**PORT STEPHENS**  
C O U N C I L

ORDINARY COUNCIL MEETING  
14 JUNE 2016

**DEVELOPMENT APPLICATION 16-2015-852-1 FOR A COMMUNITY FACILITY, RECREATION FACILITY (OUTDOOR), ASSOCIATED EARTHWORKS, SIGNAGE AND CAR PARKING (FERODALE PARK SPORTS COMPLEX) AT 36 AND 36A FERODALE ROAD, MEDOWIE (LOT 1 DP1003417 AND LOT 22 DP1021843)**

Figure 2 Example Close to Source Stormwater Treatment Measures

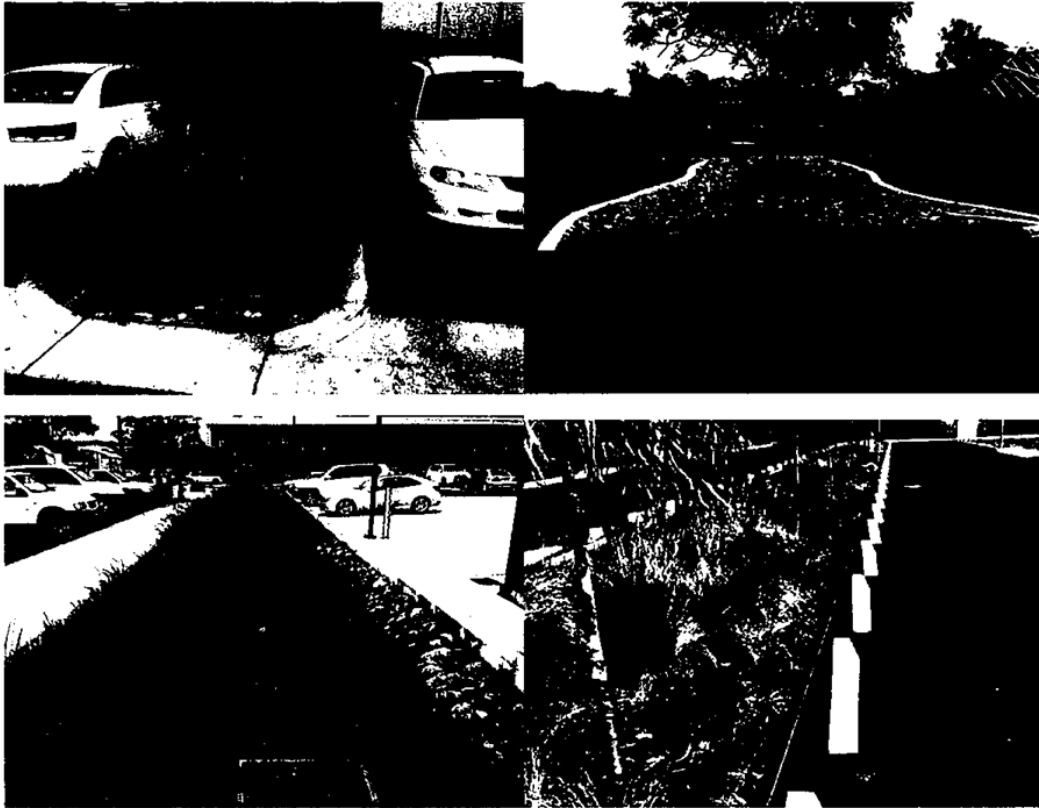
It is suggested that PSC could consider provision of stormwater treatment measures within the proposed development that are likely to be more effective than the proposed swales and constructed wetland. It is suggested that providing treatment closer to the paved areas outside of the Campvale Drain floodplain would be important for achieving a system that will be efficient to maintain into the future and be less impacted by pollutant loads conveyed from the upstream catchment.

Examples of the types of measures that may be suitable for the proposed development are shown in Figure 2. Many of these measures could effectively be integrated into the landscaping for the site and distributed throughout the development at readily accessible locations to minimise maintenance requirements.
